**SUBJECT:** Calvert Cliffs Nuclear Power Plant  
Unit Nos. 1 & 2; Docket Nos. 50-317 & 50-318  
License Amendment Request; Change to Reactor Coolant System Flow  
Requirements to Allow Increased Steam Generator Tube Plugging

Pursuant to 10 CFR 50.90, the Baltimore Gas and Electric Company hereby requests an amendment to Operating License Nos. DPR-53 and DPR-69 by incorporating the changes described below into the Technical Specifications and Updated Final Safety Analysis Report for Calvert Cliffs Unit Nos. 1 and 2. The proposed changes are necessary to support a larger number of plugged steam generator (SG) tubes for future operating cycles.

DESCRIPTION AND EVALUATION OF CHANGES  
IN SUPPORT OF INCREASED STEAM GENERATOR TUBE PLUGGING LIMIT

FIGURE 14.9-1

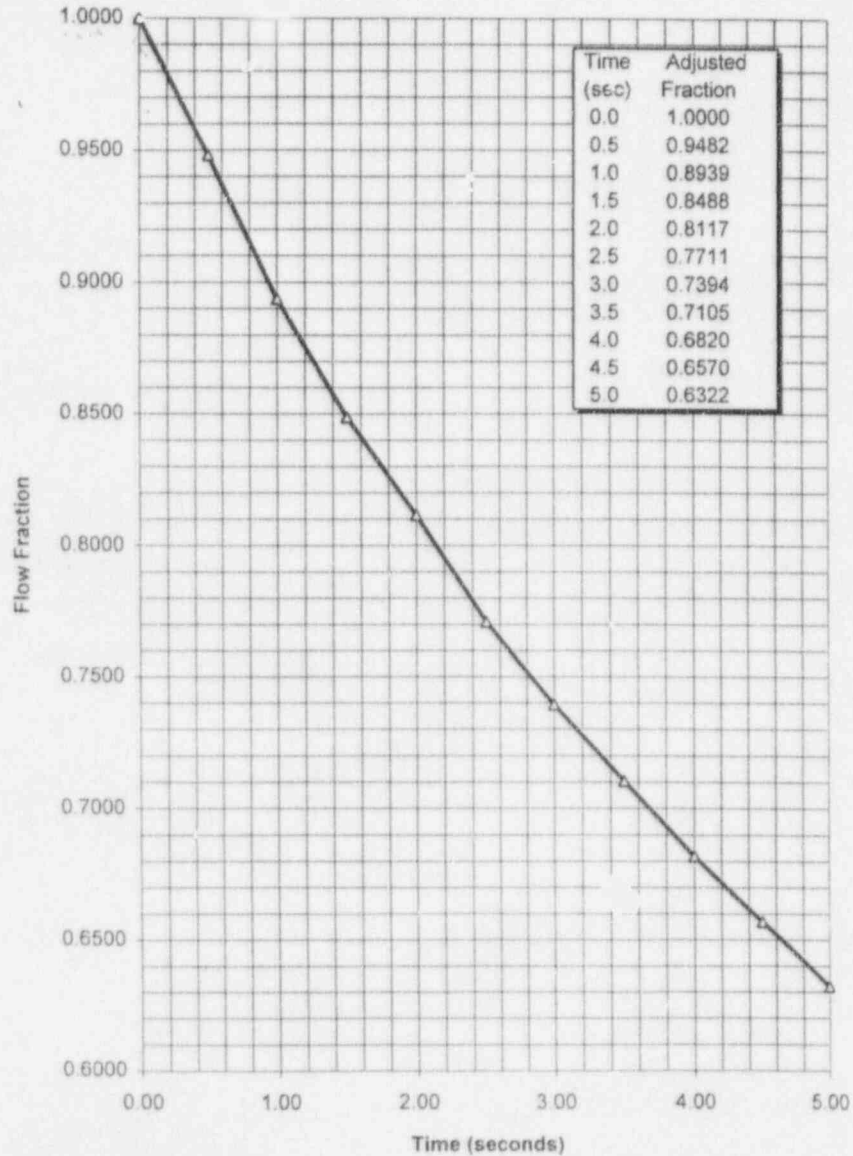
The input parameters and initial conditions used in the Loss of Coolant Flow analysis are listed in Table 14.9-1. Figure 14.9-1 is the four-pump coastdown curve used in the analysis. The axial power distributions and associated control rod reactivity used in the analysis are based on the most limiting distributions postulated to occur within the Technical Specifications LCOs. A parametric analysis is performed for rodged and unrodged axial power distributions at beginning of cycle and end of cycle conditions.
